Response to Information Request – 21 Zillmere Road, Boondall QLD 4034 (Council Reference: A006898940)

In accordance with Section 13.2 of the Development Assessment Rules and on behalf of *Shoobridge Commercial Pty Ltd* ('the Applicant'), please find below a response to the information requested by Council on 11 December 2025 for the development application at 21 Zillmere Road, Boondall (Council Ref.: A006898940).

Re: Technical Memo – Material Change of Use Application for Hotel Use – 21-23 Zillmere Road in Boondall – Acoustic Review of Environmental Noise Emissions

Drawing
**SITE PLAN EXISTING CONDITIONS - W
PROPOSED ADDITIONAL CARPARKS**

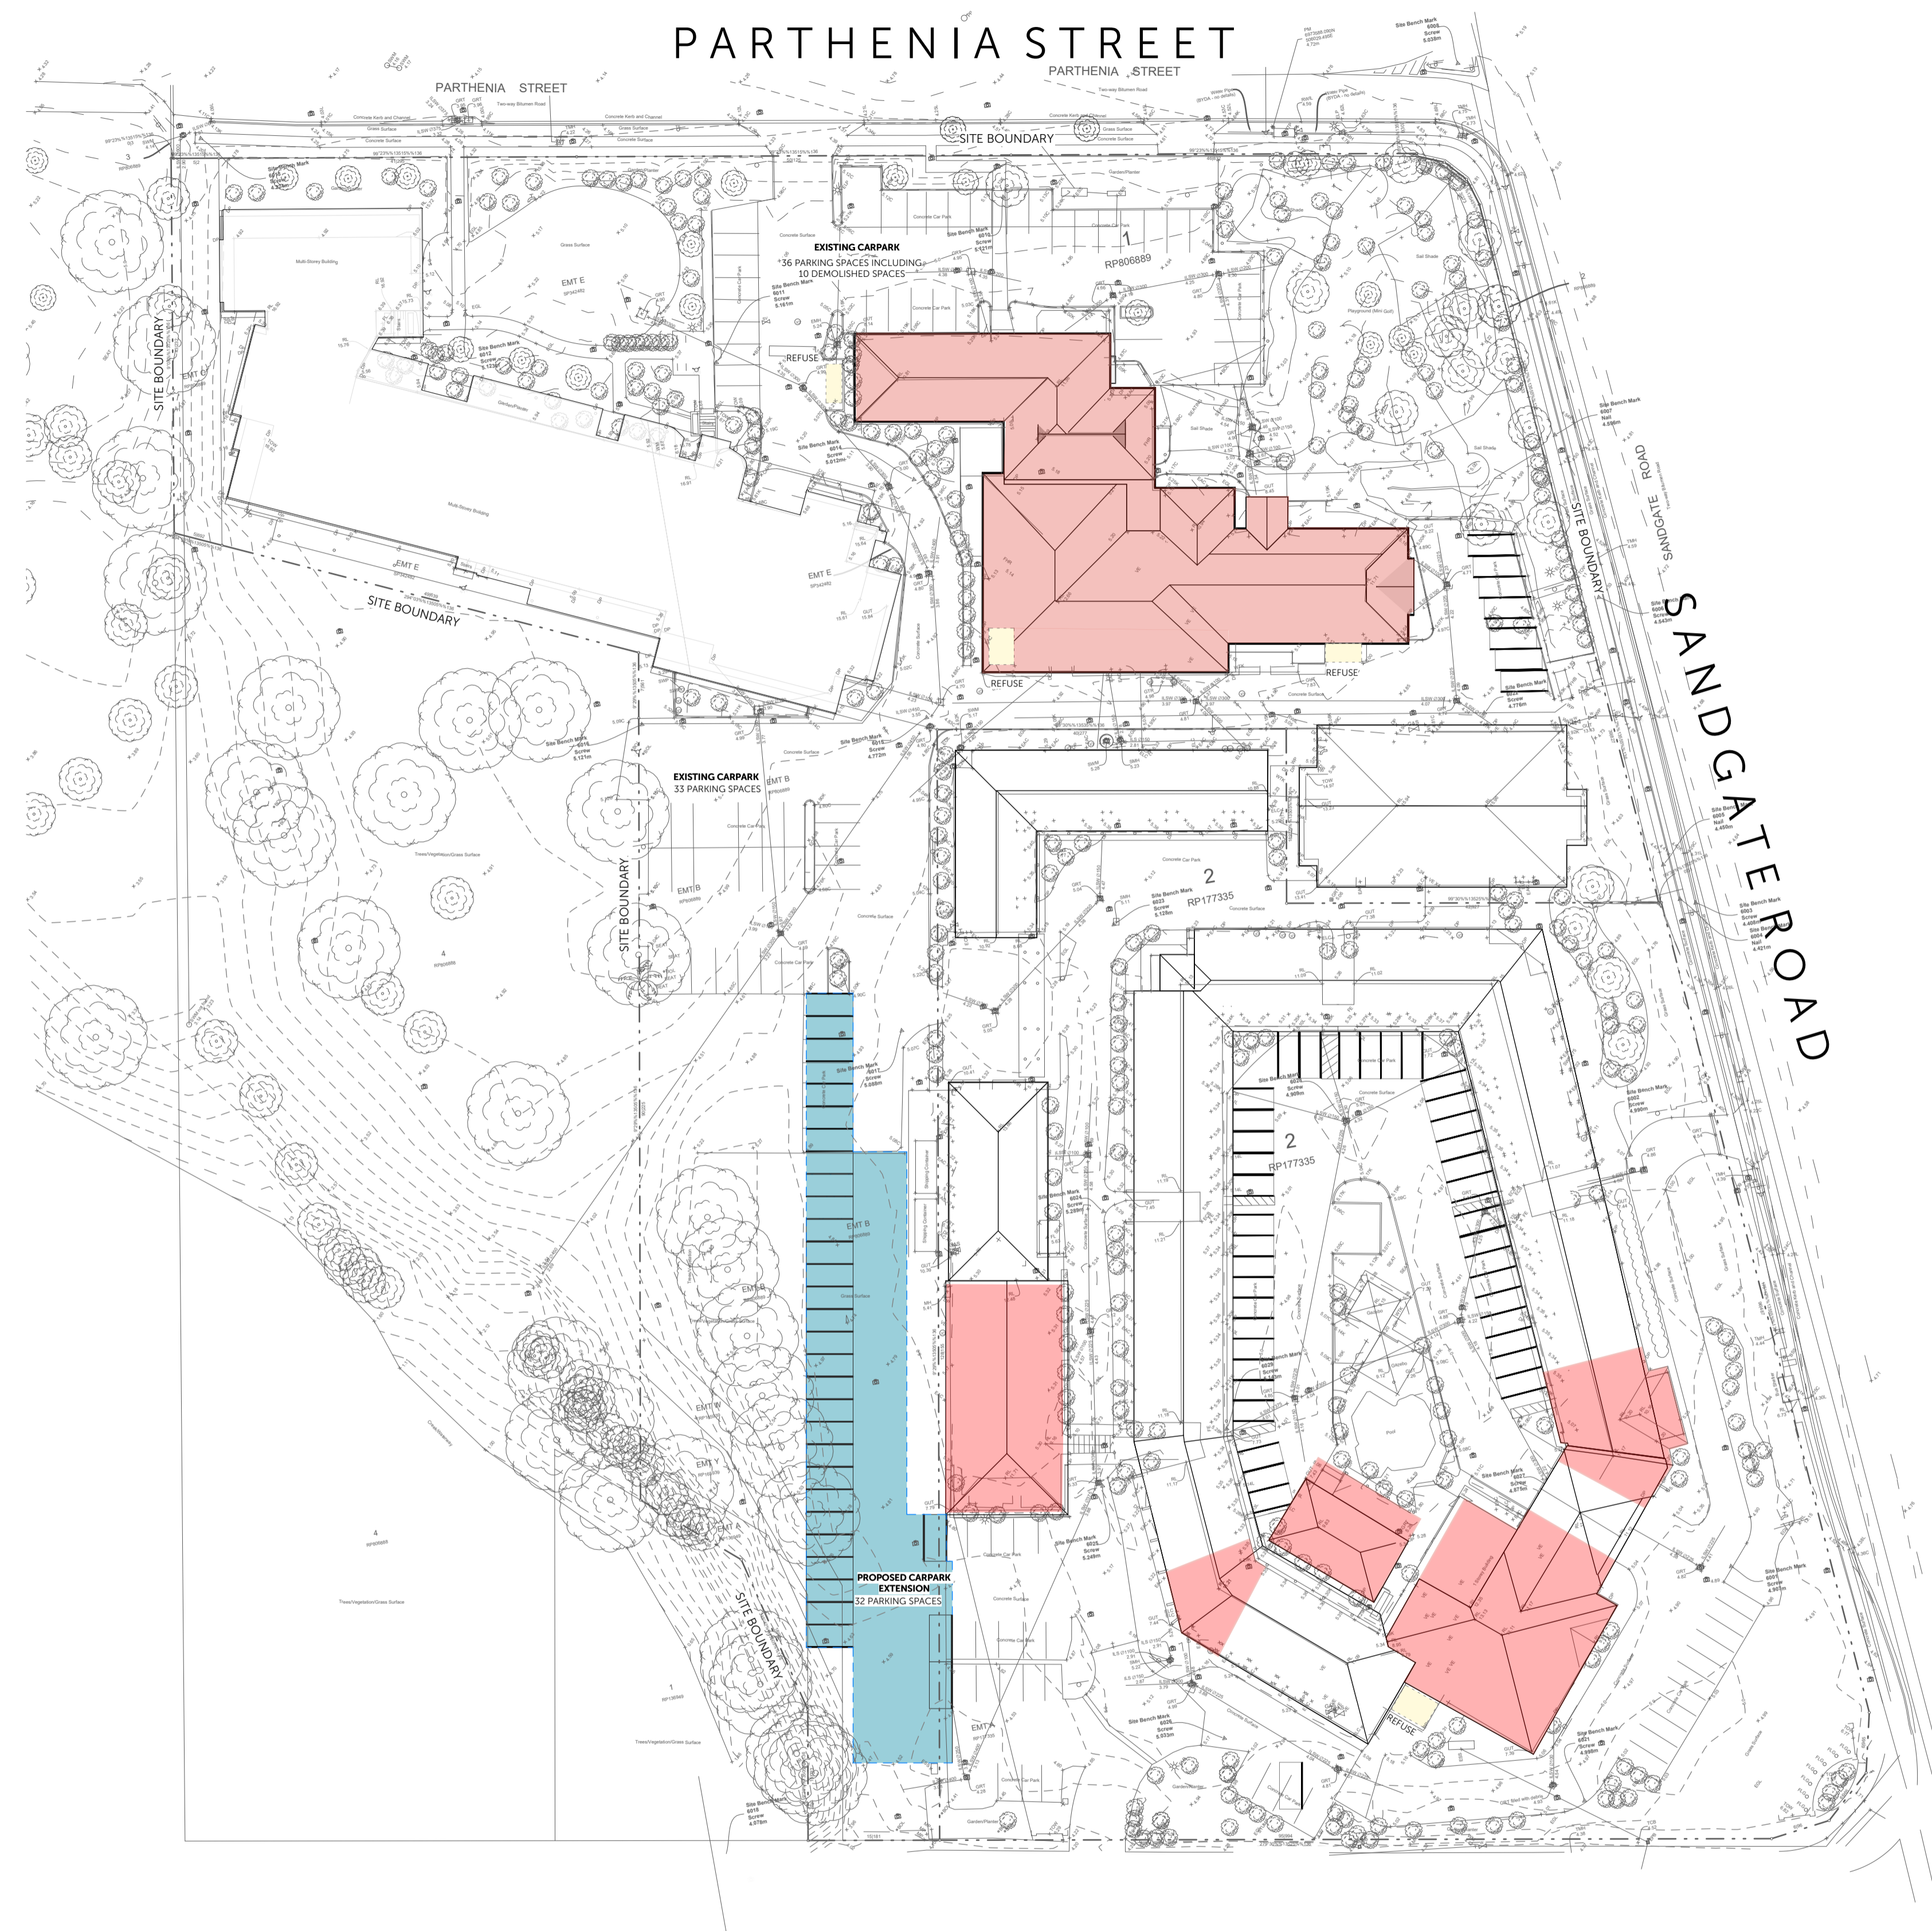
- a) A Traffic Report or Traffic Statement, endorsed by a Registered Professional Engineer of Queensland (RPEQ), that:
 - i. Addresses any proposed performance solutions;
 - ii. Demonstrates that the proposed hotel use will not adversely impact the efficient operation or safety of the surrounding road network;
 - iii. Confirms that access driveways will remain functional and unobstructed;
 - iv. Verifies that the existing number and type of parking spaces are sufficient to accommodate peak-hour demand for the amended uses; and
 - v. Confirms that expected waste generation can be effectively managed by existing servicing facilities.

The proposed plans do not demonstrate compliance with AO8.1 and AO8.2/PO8 of the Infrastructure design code regarding refuse storage and collection. Accordingly:

- a) Revise the plans to incorporate refuse storage and collection facilities in accordance with the Infrastructure design code and Refuse Planning Scheme Policy.*
- b) Demonstrate that the existing refuse storage facilities have sufficient capacity to accommodate the proposed hotel use.*
- c) Clearly show and annotate the dimensions of all refuse storage facilities on the amended plans.*

In response to this item, the Applicant proposes a minor extension to the existing parking area west of the developed area, providing 25 additional spaces for a total of 172 spaces (excluding those associated with the Multiple Dwelling use on the site). An Amended Proposal Plan has been prepared and included in **Attachment D** which illustrates the additional parking area.

- a) The Amended Proposal Plan now identifies refuse storage and collection areas, as shown in **Attachment D**.
